# 800GBASE-LR1

# Permutation function

In support of comment #

Leon Bruckman, Nvidia

Figure 184–3—Lane permutation

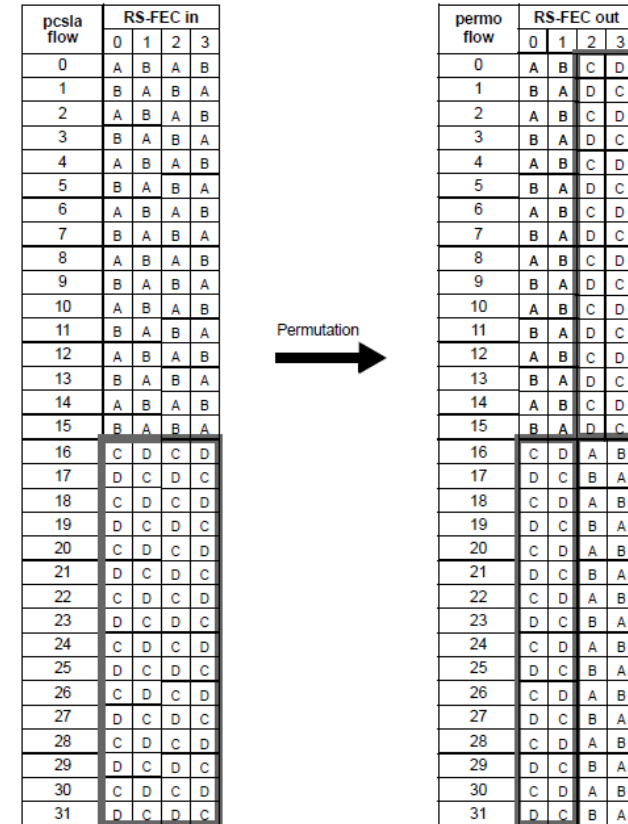
- Figure 184-3 implies that the odd/even PCS lanes are assigned to odd/even  $pcsla$  flows
- It also implies that the PCS lanes 0-15 are assigned to  $pcsla$  flows 0-15 and the PCS lanes 16-31 to  $pcsla$  flows 16-31
- This contradicts the lane grouping definition

## Suggested remedies:

Either delete Figure 184-3 and the reference to it, or replace Figure 184-3 and change the text in 184.4.3 as follows:

The lane permutation function shall rearrange the RS-FEC symbols of the pcsla[q, i] Inner FEC flows to create 32 output flows such that each group of four consecutive symbols on each output flow contains one symbol from each of the four RS-FEC encoders in the 800GBASE-R PCS. **Figure 184–3 shows an example of the lane permutation function operation.**

Figure 184-3—Lane permutation

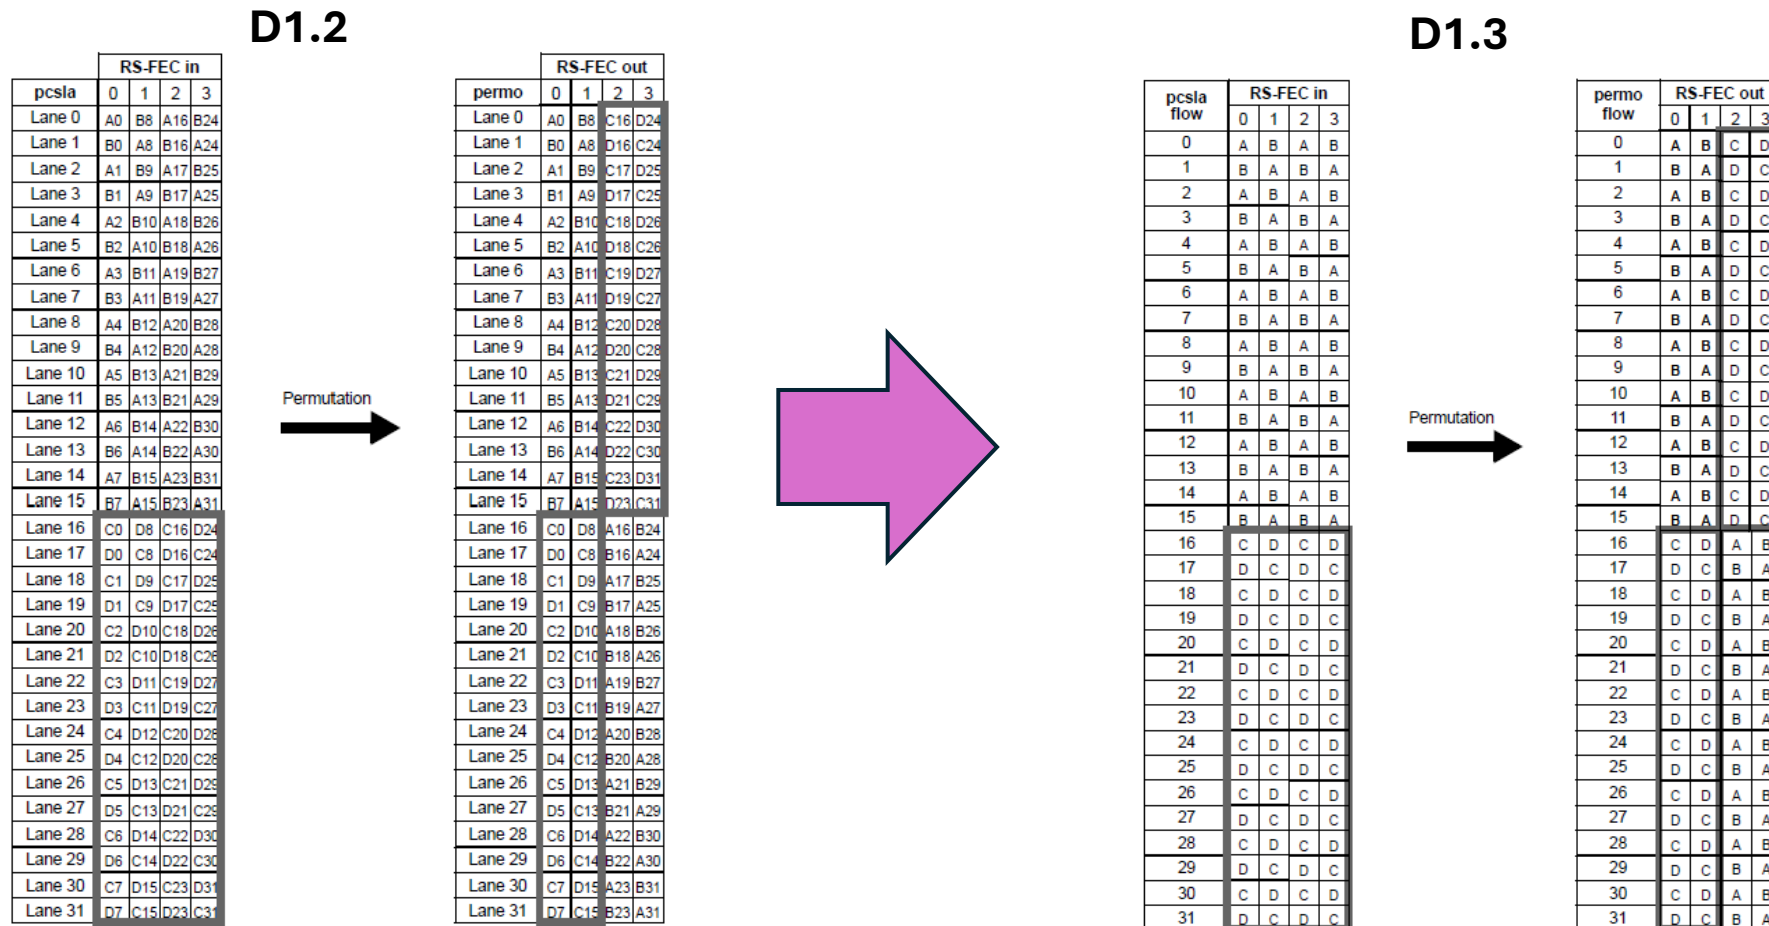
- As part of the resolution of comment #422 against D1.2, Figure 184-3 was changed to make it more general.
